SOUTH CAROLINA ELECTRIC & GAS COMPANY
 VIRGIL C. SUMMER NUCLEAR STATION
 NUCLEAR OPERATIONS

FIRE EMERGENCY PROCEDURE

FEP-4.0

CONTROL ROOM EVACUATION DUE TO FIRE

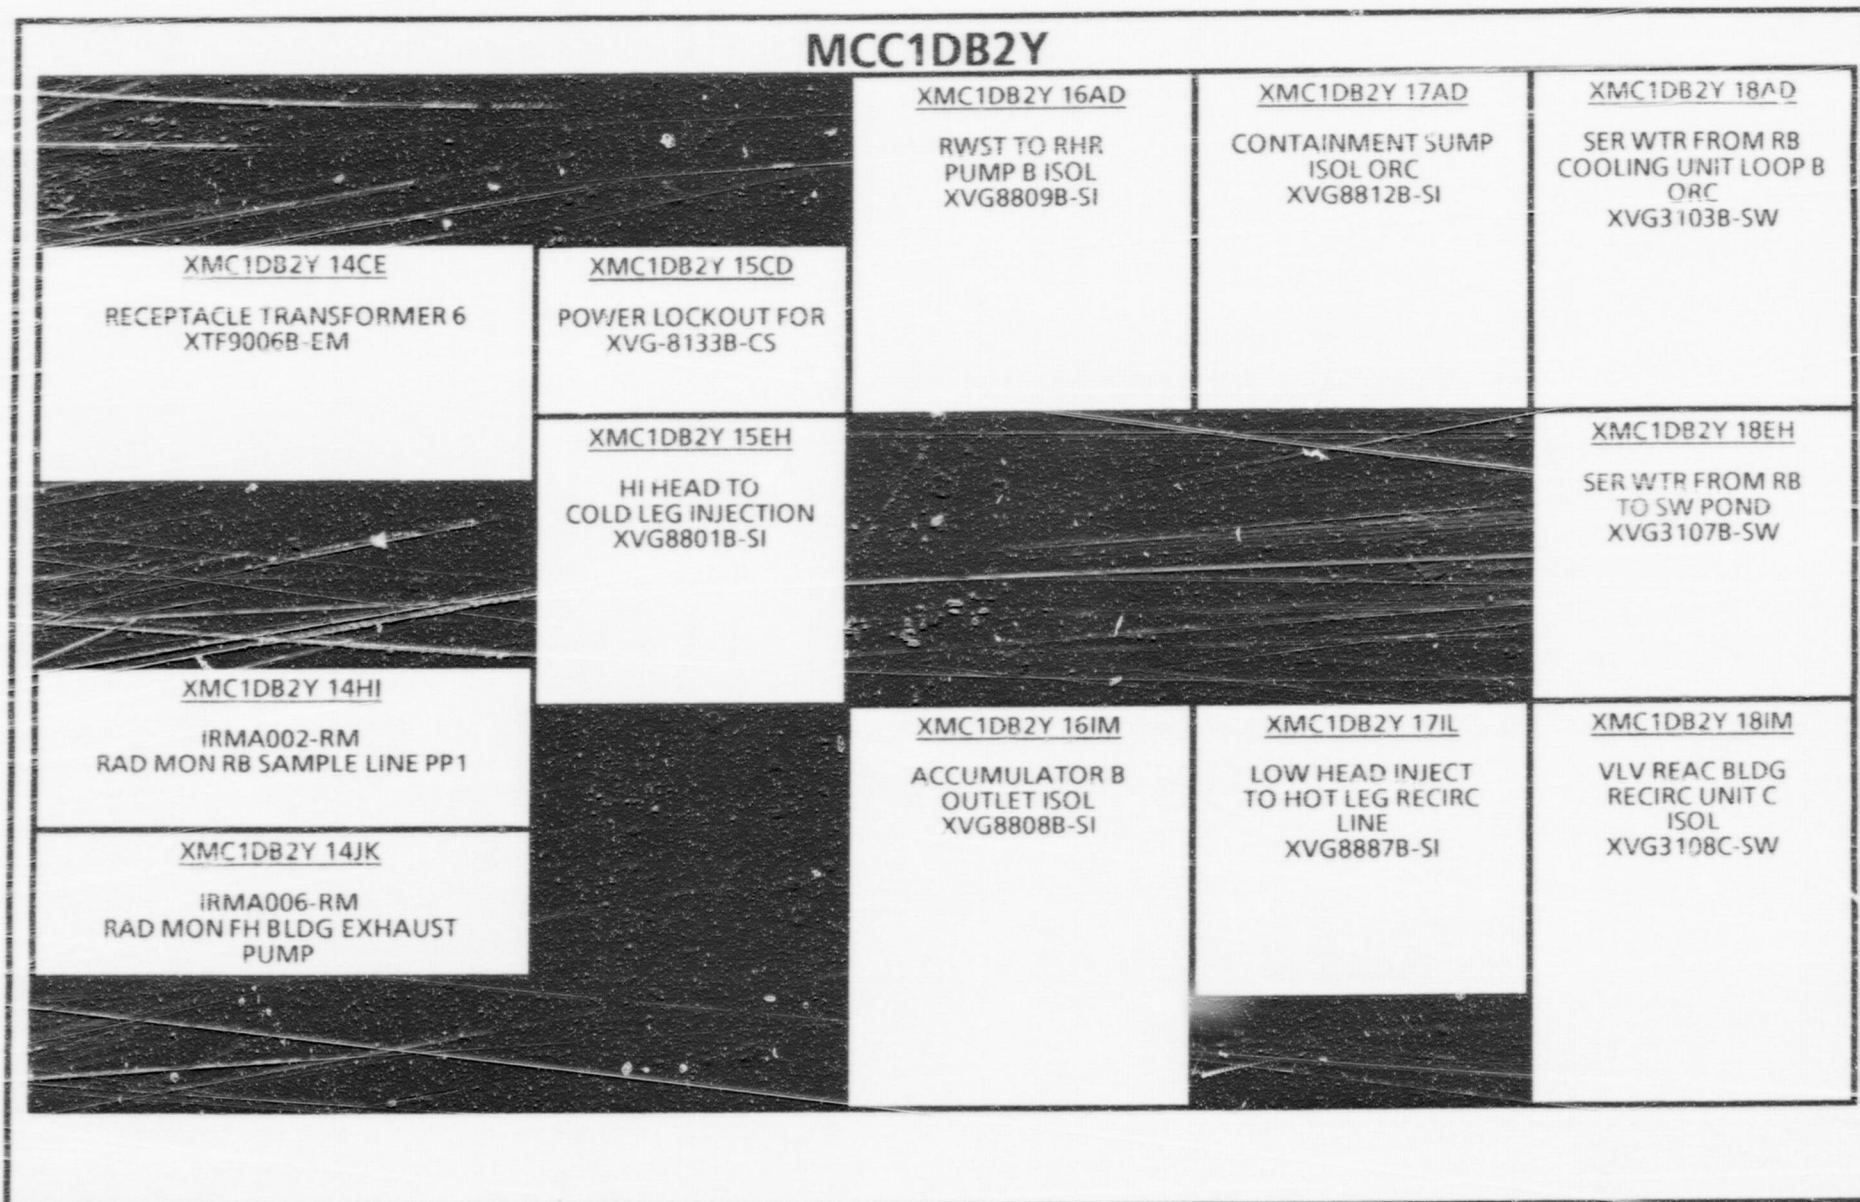
II. DESCRIPTION: Incorporate Power Lockouts for XV6-8133A and XV6-8133B

CHG
E
